WORKING DRAFT OF NEC[®] CODE MAKING **PANEL 4 MEETING OUTPUT**

Document: National Electrical Code[®]

Revision Cycle: A2019

Committee Activity: Comment Stage

Figure Informational Note Figure 690.1(a) Identification of PV Power Source Components.
[REVISE FIGURE PER ATTACHED]

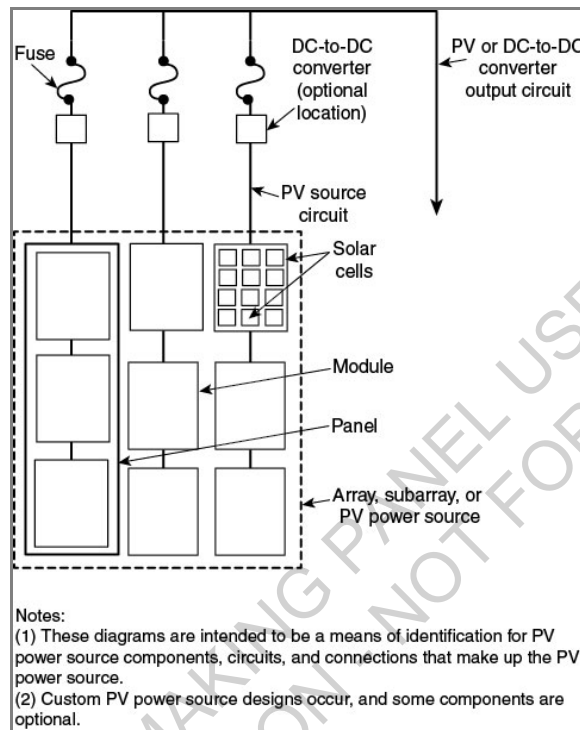
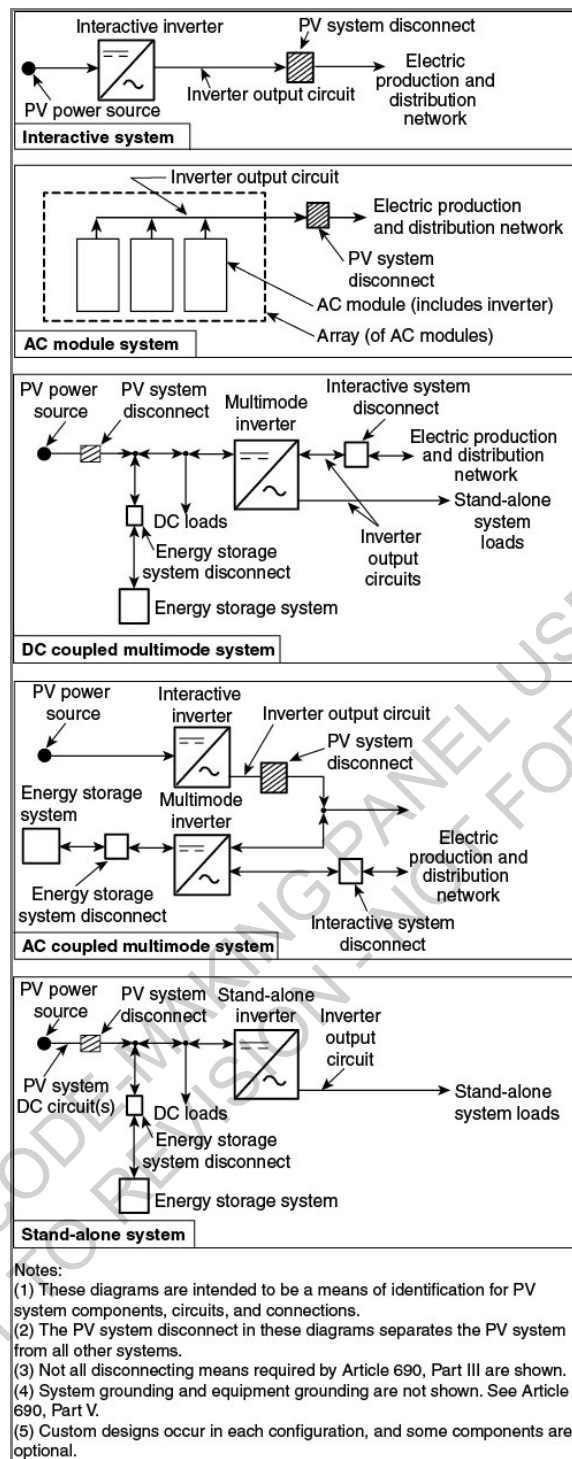
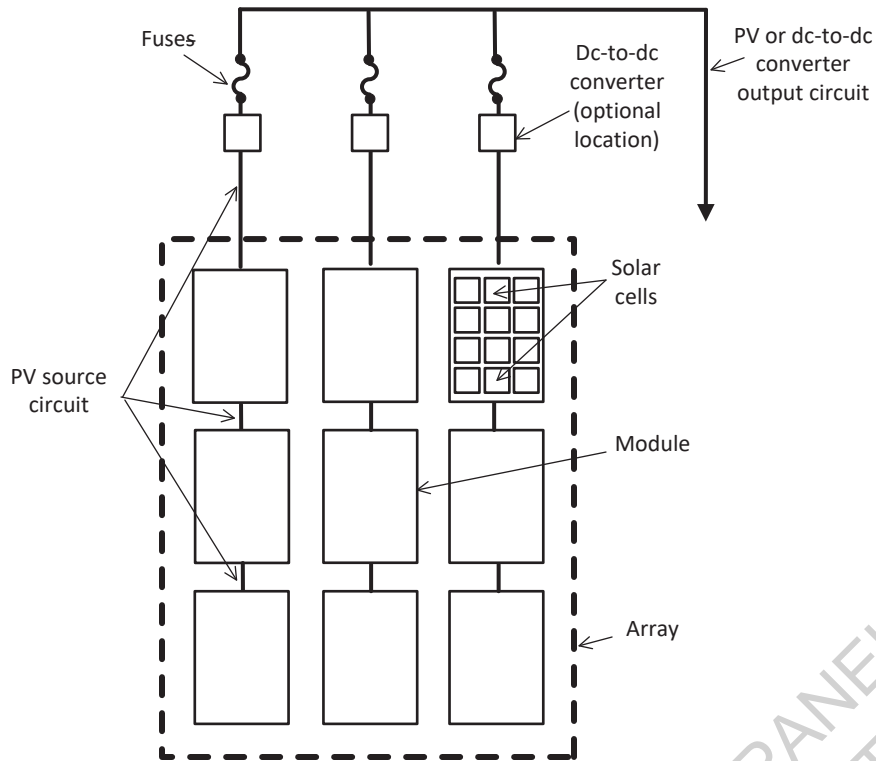
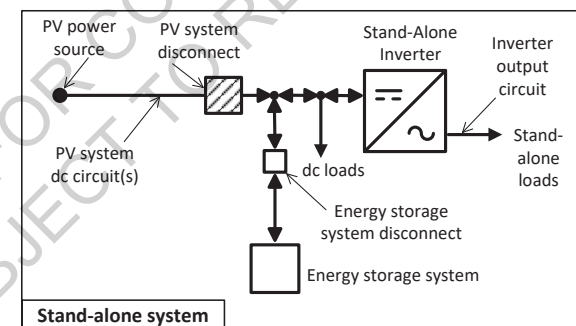
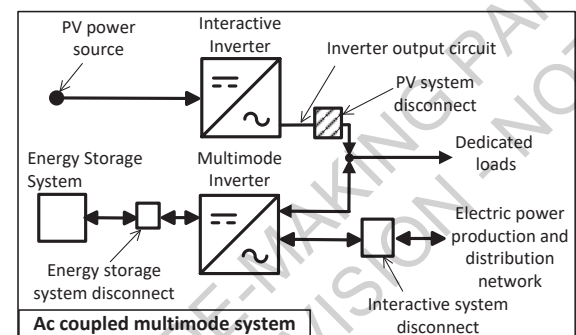
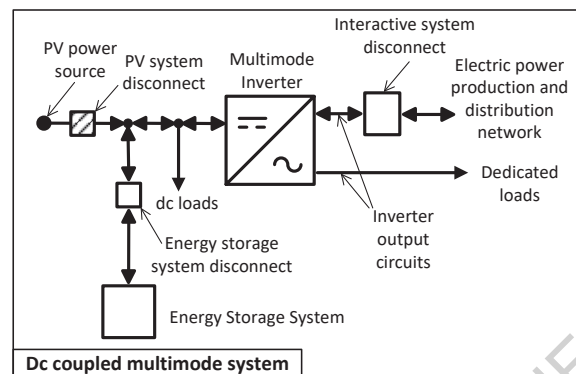
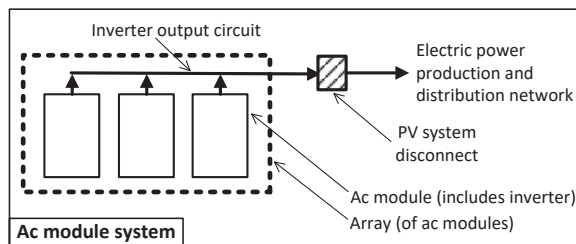
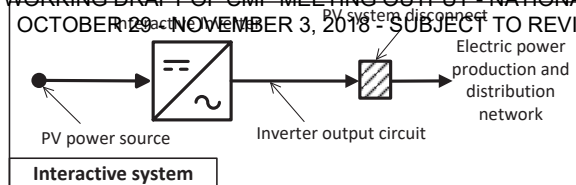
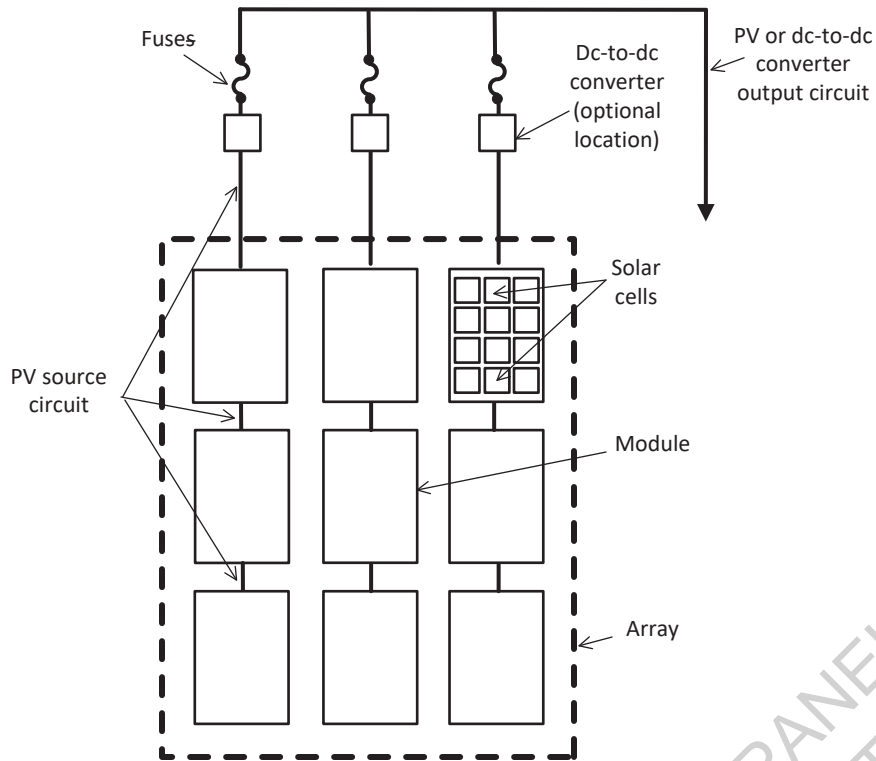
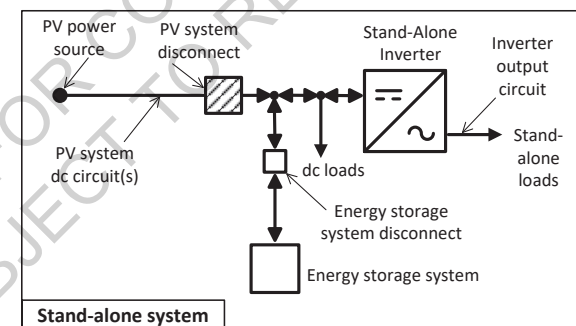
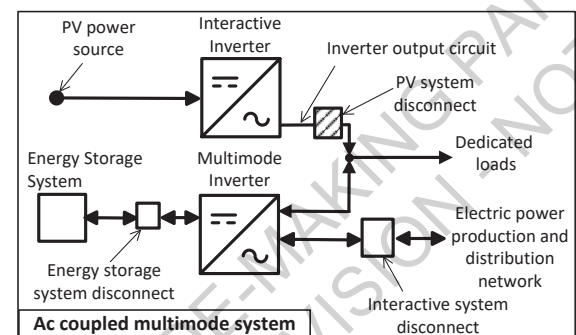
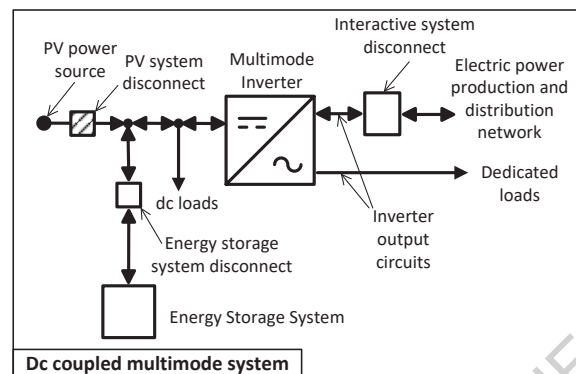
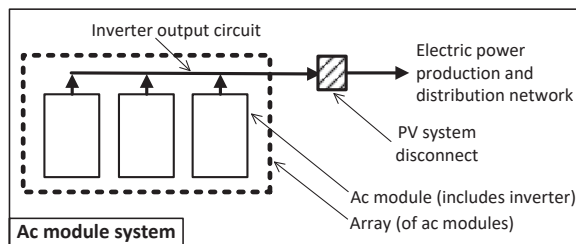
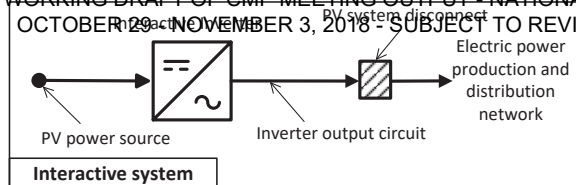
Figure Informational Note Figure 690.1(b) Identification of PV System Components in Common Configurations. **[REVISE FIGURE PER ATTACHED]**

Committee Statement: The informational note figures were supposed to be revised on First Revision 8568, but the revisions were not implemented in the draft. This revision enacts those changes.

Informational Note Figure 690.56(C) Label for Roof-Mounted PV Systems with Rapid Shutdown.

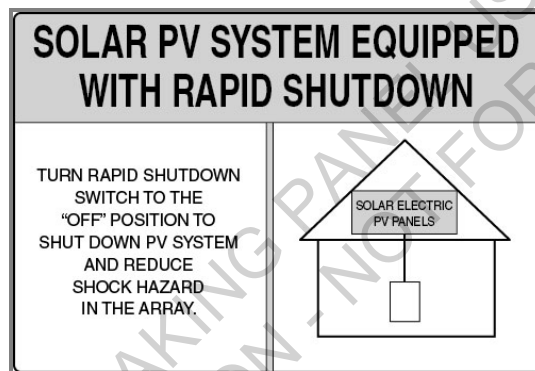
The figure title has been changed to include the identification that it is an informational note.
